From: Benzie, Richard (DEQ)
Sent: Friday, October 02, 2015 4:01 PM
To: Cook, Pat (DEQ)
Subject: FW: Flint schematic in OEL

From: Crooks, Jennifer [<mailto:crooks.jennifer@epa.gov>]
Sent: Friday, October 02, 2015 12:46 PM
To: Busch, Stephen (DEQ); Prysby, Mike (DEQ); Rosenthal, Adam (DEQ); Benzie, Richard (DEQ)
Cc: Poy, Thomas
Subject: Flint schematic in OEL

From: Porter, Andrea
Sent: Friday, October 2, 2015 9:56 AM
To: Crooks, Jennifer; Schock, Michael; Lytle, Darren
Cc: Poy, Thomas; Deltoral, Miguel
Subject: RE: Flint schematic

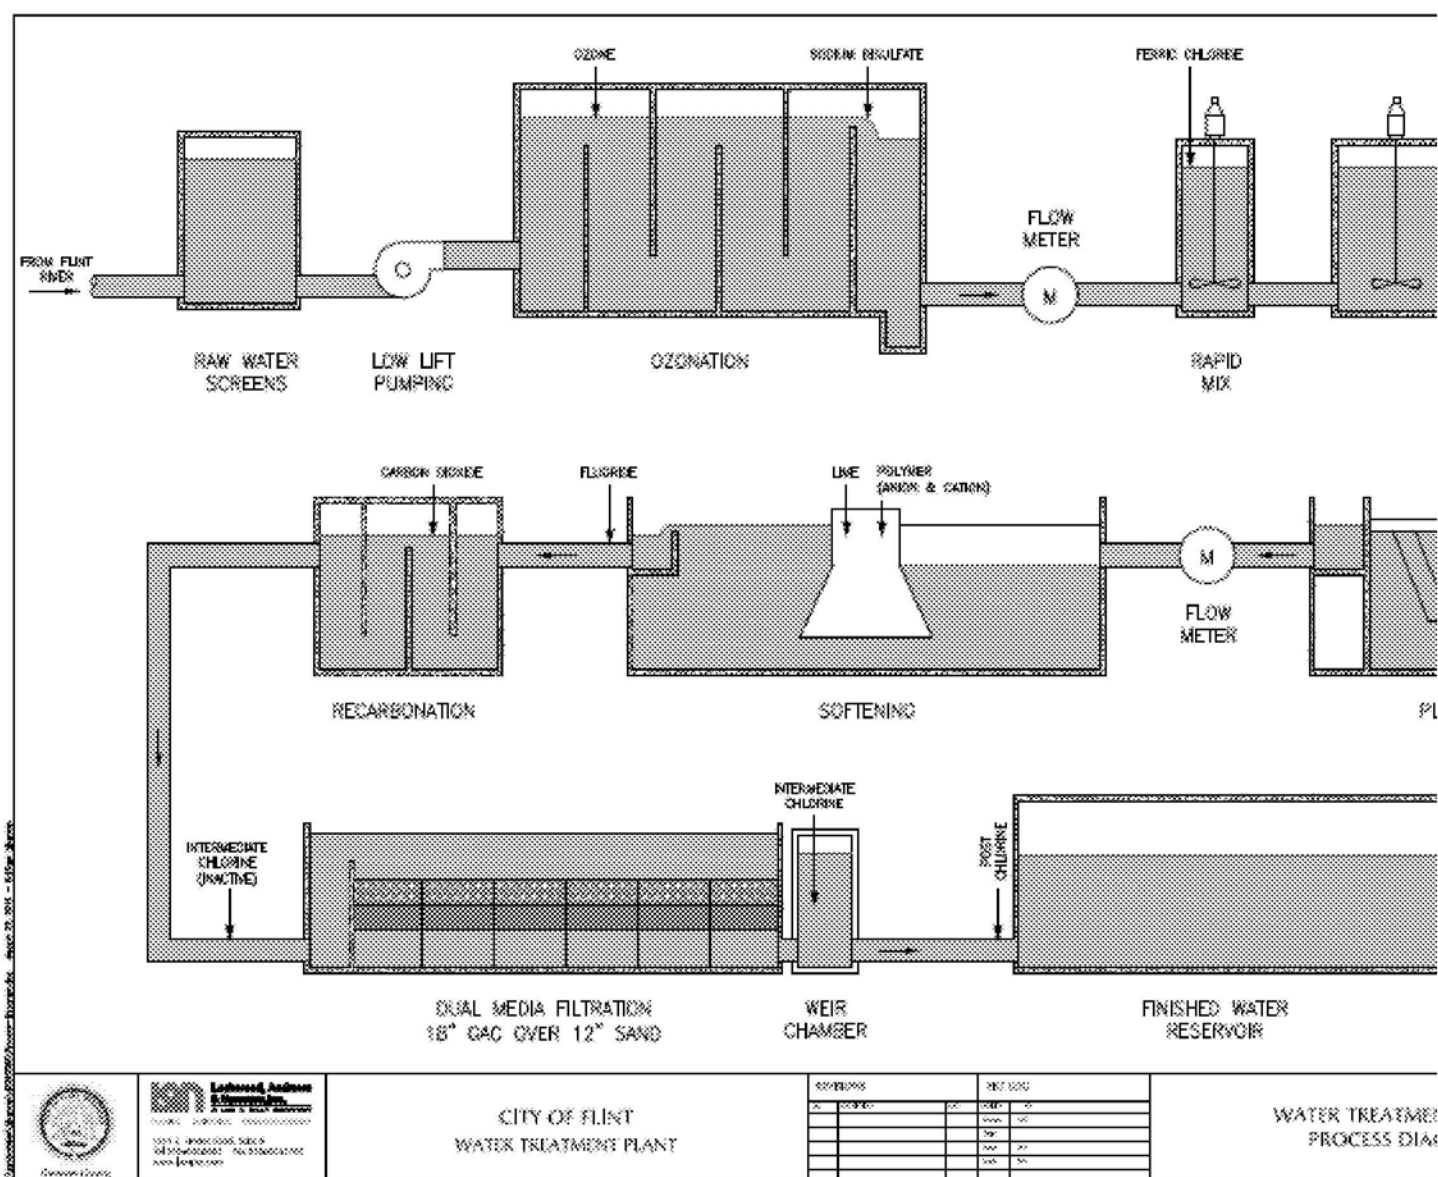
Have we routinely allowed filter plants to have only 12-inches of sand in there dual-media filters?
